Product Bulletin 2019.1

RE: MCS-1000 Tier 4 Models, Clutch Override Button

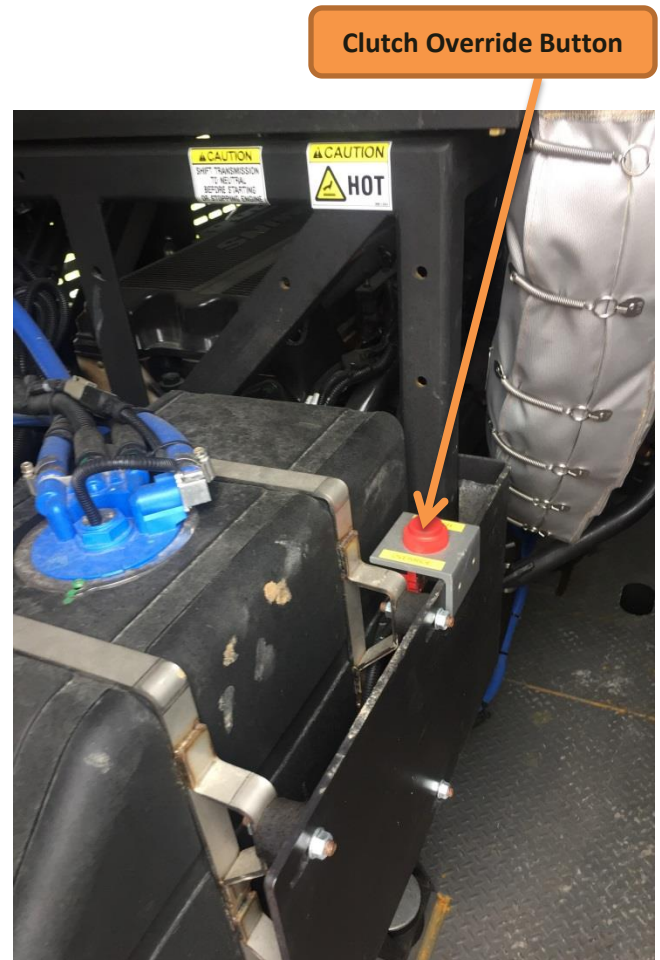
On occasion when preparing to change gears on the drive engine transmission, it may be difficult to shift into the desired gear due to gear teeth being in random alignment. As a running change, we have added a clutch override button as pictured below within the enclosure mounted by the DEF tank.

In these cases, momentarily push the override button to engage the clutch and allow the gears to rotate, then release the button. Gently shift into your desired gear. (button must be released before shift is made)
